Access Compliance Report

Public Rights-of-Way

Intersection ID: 2983	Main Street: YELLOW_ROSE_LN	Cross Street: BROWNE_RD	Location: SE
ADA ID: 7813CB02AB4B	Ramp Type: Perp	Initial Pass/Fail: Fail	Overall Compliance: No
Codes/Mitigation Info/Possible Solution		Field Measurements/Component Compliance	
Severity Score: 33.75

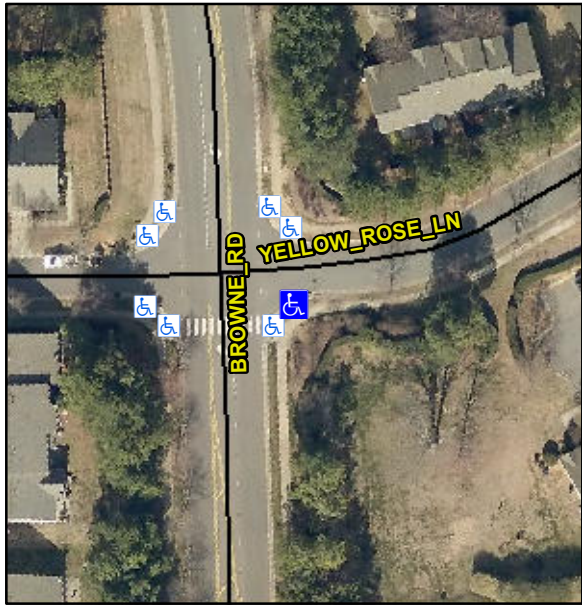
Possible Solutions:									
	Remove & Replace Entire Ramp.									
	Surveyor Notes:									
	N/A									
	PROW/ADA:									
	R304.5.1, R304.2.2, R304.5.3									
	Total Cost:	\$	1850.00							
Street 1 Name		YELLOW ROSE LN								
Stop Condition-Street 2		StopSign								
Street 2 Name		N/A								
Stop Condition-Street 1		N/A

Compliance	Description	Data	Compliance	Description	Data
N/A	Ramp Length (in)	61.0	No	Ramp Slope (%)	8.9
No	Ramp Width (in)	44.0	No	Ramp XSlope (%)	6.1
N/A	Flare Type LT	N/A	N/A	Flare Type RT	N/A
N/A	Flare Slope LT (%)	N/A	N/A	Flare Slope RT (%)	N/A
N/A	Flare Traversable LT?	N/A	N/A	Flare Traversable RT?	N/A
N/A	Landing Length (in)	N/A	N/A	DWS Provided?	N/A
N/A	Landing Width (in)	N/A	N/A	DWS Contrast?	N/A
N/A	Landing Slope (%)	N/A	N/A	DWS Length (in)	N/A
N/A	Landing X Slope (%)	N/A	N/A	DWS Full Width?	N/A
N/A	Landing Curb? (Y/N)	N/A	N/A	DWS Offset (in)	N/A
N/A	Shared Landing?	N/A			
N/A	Gutter Ponding?	N/A	N/A	Gutter Slope (%)	N/A
N/A	Gutter Lip Ht (in)	N/A	N/A	Gutter X Slope (%)	N/A
N/A	Painted X Walk1?	No	N/A	Painted X Walk2?	N/A
	X Walk 1 Direction	To N		X Walk 2 Direction	N/A
N/A	X Walk 1 Width (in)	N/A	N/A	X Walk 2 Width (in)	N/A
	X Walk 1 Slope (%)	0.2		X Walk 2 Slope (%)	N/A
	X Walk 1 X Slope (%)	4.6		X Walk 2 X Slope (%)	N/A
